SUBJECT: TURKEY POINT NUCLEAR GENERATING UNIT NOS. 3 AND 4 - ISSUANCE
OF AMENDMENTS REGARDING TECHNICAL SPECIFICATION FIGURE FOR
THE BORIC ACID TANK MINIMUM VOLUME (CAC NOS. MF6148
AND MF6149)

The amendments revise TS Figure 3.1-2, "Boric Acid Tank Minimum Volume," to reflect corrections to an instrument uncertainty calculation.

SAFETY EVALUATION BY THE OFFICE OF NUCLEAR REACTOR REGULATION FOR
AMENDMENT NO. 270 TO RENEWED FACILITY OPERATING LICENSE NO. DPR-31 AND
AMENDMENT NO. 265 TO RENEWED FACILITY OPERATING LICENSE NO. DPR-41
FLORIDA POWER & LIGHT COMPANY
TURKEY POINT NUCLEAR GENERATING UNIT NOS. 3 AND 4
DOCKET NOS. 50-250 AND 50-251

Figure 3.1-2
 BORIC ACID TANK MINIMUM VOLUME (1)
 Modes 1, 2, 3 and 4

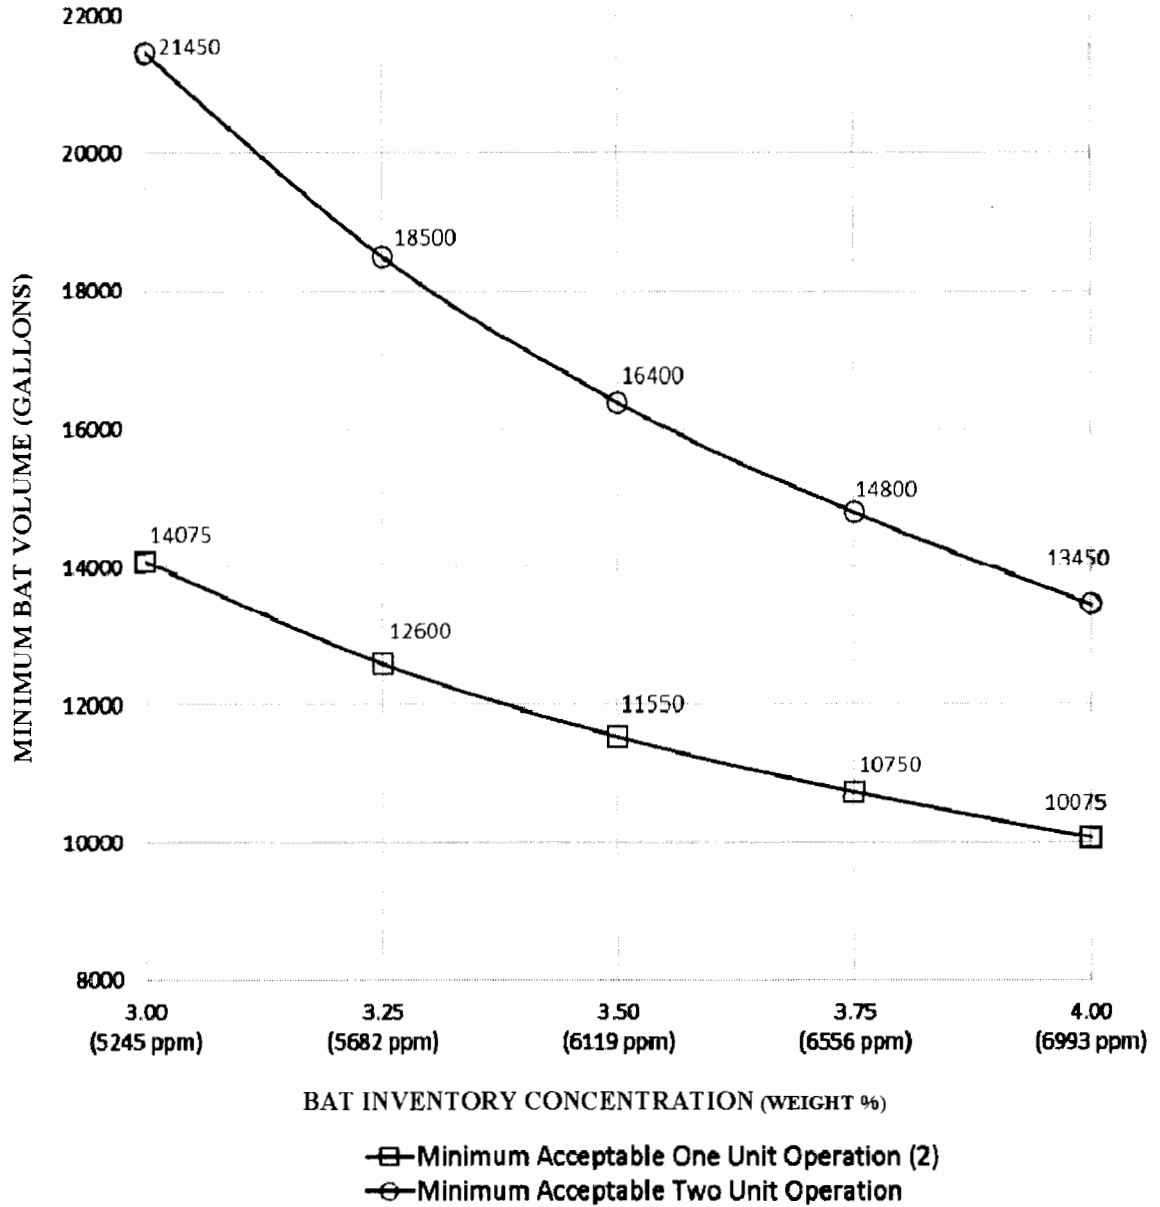
The licensee proposed to revise TS Figure 3.1-2 to reflect corrections to an instrument uncertainty calculation and to correct nonconservative TS requirements. The curves in TS Figure 3.1-2 incorporate an instrument uncertainty of 600 gallons for one-unit operation and 1200 gallons for two-unit operation. These values were approved in Amendment Nos. 249 and 245, which the NRC issued for Unit 3 and 4, respectively, on June 15, 2012.³ However, the licensee identified two issues in its calculation of the minimum acceptable BAT volume for a given boron concentration.

In its application dated April 16, 2015, the licensee stated that the instrument uncertainty of 600 gallons was erroneously doubled to 1200 gallons and included in the BAT minimum volume curve for two-unit operation. The licensee stated that the BATs are common equipment that serves both units and, therefore, the instrument uncertainty for two-unit operation should not have been counted twice when establishing the minimum acceptable BAT volume curve.

In its application dated April 16, 2015, the licensee also indicated that when calculating the total loop uncertainty (TLU) for the BAT instrumentation that monitors BAT level, the conversion of the TLU into equivalent tank volume uncertainty (in gallons) was incorrectly calculated based on the volume of a single BAT. The calculation should have considered the volume of a common tank comprised of three BATs cross-tied together. Therefore, the calculated TLU was underestimated, which resulted in the instrumentation uncertainty increasing from 600 gallons to

900 gallons. This issue impacts both the one-unit operation curve and the two-unit operation curve in TS Figure 3.1-2.

In summary, both curves in TS Figure 3.1-2 should reflect an instrument uncertainty of 900 gallons. The licensee proposed to revise Figure 3.1-2 by shifting the one-unit operation curve up by 300 gallons, which would correct a nonconservative TS, and the two-unit operation curve down by 300 gallons in order to reflect the correct instrument uncertainty values for both curves.

Because the current BAT volume requirements in TS Figure 3.1-2 for one-unit operation assumes a TLU value of 600 gallons, the licensee proposed adding 300 gallons to those values to reflect the 900-gallon TLU value. Because the current BAT volume requirements in TS Figure 3.1-2 for two-unit operation assumes a TLU value of 1200 gallons, the licensee proposed subtracting 300 gallons from those values to reflect the 900-gallon TLU value.

Because the nominal minus uncertainty values assumed in the evaluations to achieve cold shutdown are unchanged in the proposed amendment, Turkey Point GDC 30, which requires the reactivity control system be capable of making and holding the core subcritical under any conditions with appropriate margin for contingencies, and the 10 CFR 50.36 requirement to have LCOs that are the lowest functional capability of equipment to perform their safety operation, continue to be met with the proposed amendments. The staff also determined that the licensee's calculation methodology and results are adequate and consistent with safety analysis assumptions and NRC guidance. Thus, the staff finds that the proposed TS change will not adversely affect plant operation, impact the performance of safety-related equipment, or otherwise compromise the public health and safety. The staff concludes that the proposed changes to TS Figure 3.1-2 are acceptable.
